Reference: Cambridge Crossing Parcel H Design Review Revision
Cambridge Crossing Parcel G Design Review Revision
Request for Minor Amendment
PB #179
Cambridge, Massachusetts

DESIGN REVIEW REVISION

BUILDING G AND BUILDING H PEDESTRIAN BRIDGE - CDD STAFF MEETING COMMENTS FROM VIRTUAL MEETING ON MAY 24, 2021

TYPICAL BRIDGE PARAPET DETAIL

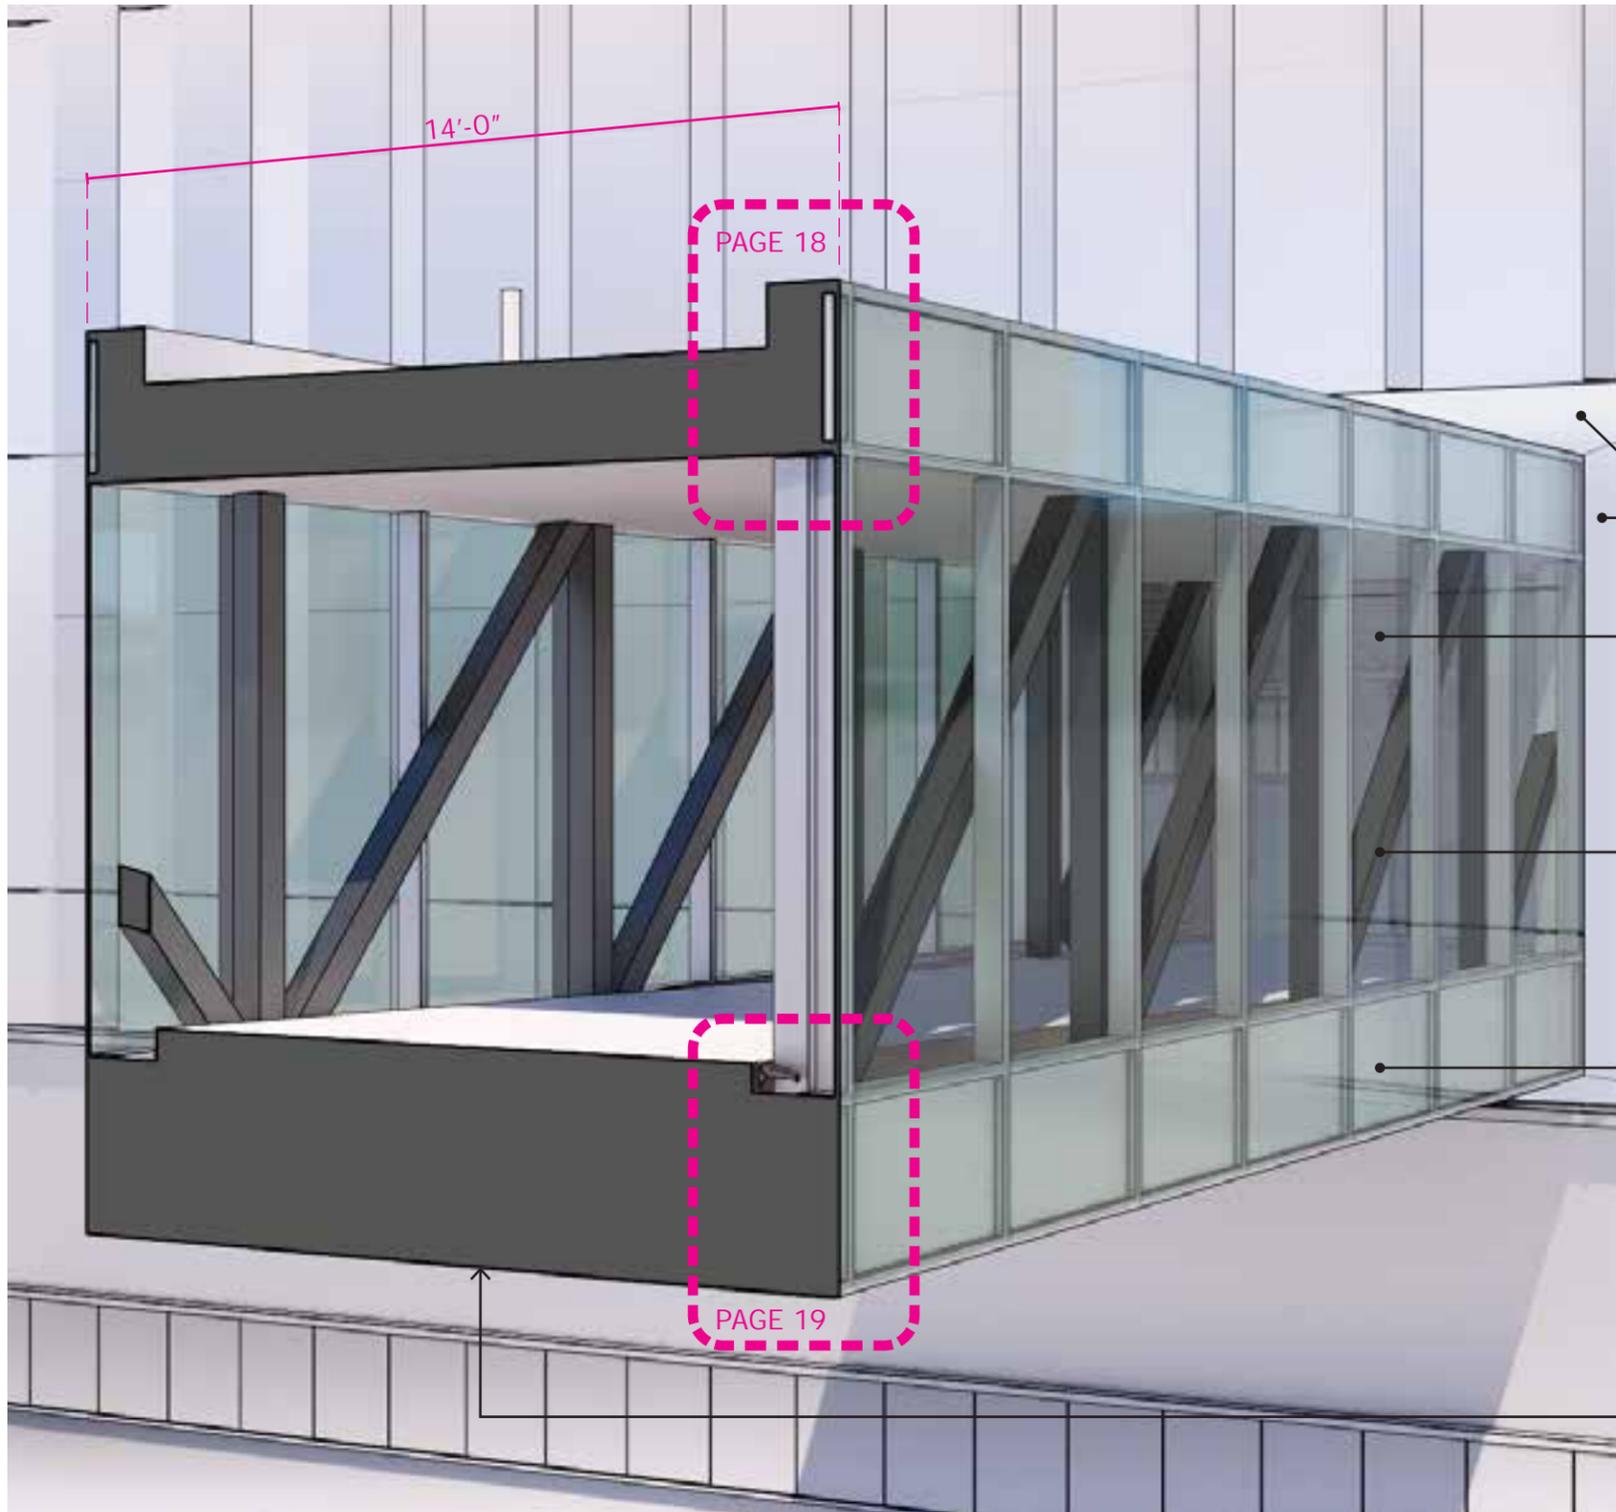
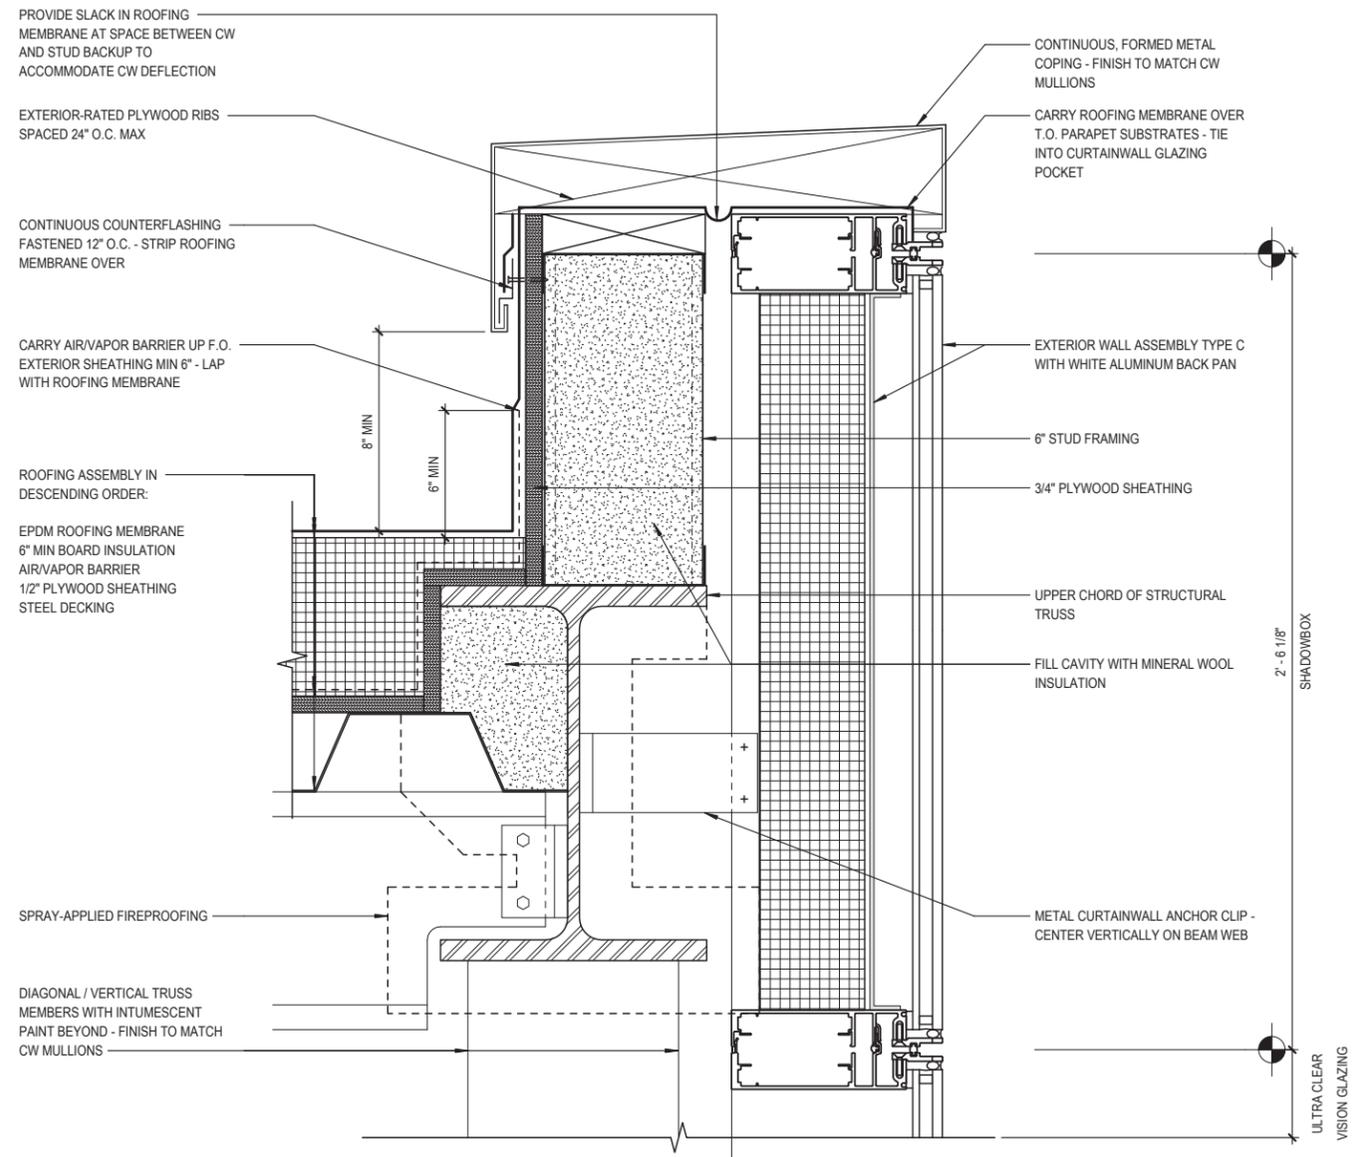
a. <i>Can the glass be more transparent?</i>	Yes - We have changed glass based on staff comments and selected the 1 1/8" IGU (High-VLT Insulated Glazing Unit) which was the same glass used at the main building lobby's curtainwall to address previous CDD transparency concerns. This glass will be used as the vision glass for both pedestrian bridges.	17	Yes

b. <i>Can the structure be expressed more?</i>	Yes - We have changed the paint finish on the structure based on staff comments. The exposed structure will be primed and painted to match the darker, Pewter color of the curtainwall mullions. This will contrast with the ultra-transparent glass and light shadowbox color to make it more apparent. The change to a more transparent glass will help express the structure when viewed from the ground plane.	17	Yes

i. <i>What is the spandrel material?</i>	The spandrels are glass with a painted metal shadow box back panel. The glass material is the same as noted in 5a above and the color of the painted metal shadow box back panel is UC1345XL Duranar XL white silver (3 coat) using UC51742 Primer & UC134595 clear-coat. This finish is similar to the vertical fins of Building H and the horizontal sun shades of Parcel G.	17	Yes
ii. <i>Can the spandrels be thinner?</i>	Yes - In response to staff comments we reduced the vertical dimension of the spandrel and increased the amount of vision glass. We were able to reduce the top spandrel dimension from 3'-3 1/2" to 2'-7 1/2" - a reduction of 8" (19.23%). We were able to reduce the bottom spandrel dimension from 3'-7 1/2" to 3'-4 1/2" - a reduction of 3" (6.9%).	17-19	Yes

6. <i>What is the material of the underside of the bridges?</i>	The underside of the bridges are composite metal panel.	17	Yes
a. <i>Can the color of the metal panel on the underside of the bridges be a lighter color?</i>	Yes - We have changed the metal panel finish based on staff comments and selected three coats of Valspar 399C049 Fluropon Classic II - Pewter	17	Yes

- FORMED METAL PANEL TRIM AT BUILDING INTERFACE
- ULTRA-CLEAR VISION GLASS
- PAINT-COATED STRUCTURAL TRUSS
- GLASS SHADOW BOX
- COMPOSITE METAL PANEL SOFFIT

METAL PANEL SOFFIT
 COLOR: (3) Coats of Valspar 399C049
 Fluropon Classic II - Pewter

ULTRA-CLEAR VISION GLASS
 1 1/8" IGU (High-VLT Insulated Glazing Unit)

SHADOW BOX GLASS
 1 1/8" IGU (High-VLT Insulated Glazing Unit)

SHADOW BOX GLASS
 UC1345XL Duranar XL white silver (3 coat)
